Amendments to the Drawings

Remarks

Summary of Office Action

FIG. 1

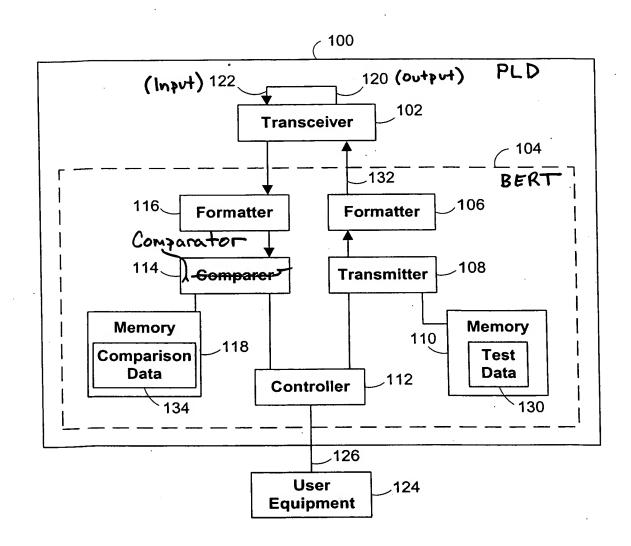
Amendments to FIGS. 1 and 3 on drawings sheets 1 and 3, respectively, are shown on the two annotated drawings sheets labeled "Annotated Sheet" appended hereto. Two corresponding replacement drawing sheets labeled "Replacement Sheet" are also appended hereto.

FIG. 1 of the drawings is objected to pursuant to 37 C.F.R. § 1.84(o).

Applicants have amended the drawings to clarify certain elements contained therein. No new matter has been added.
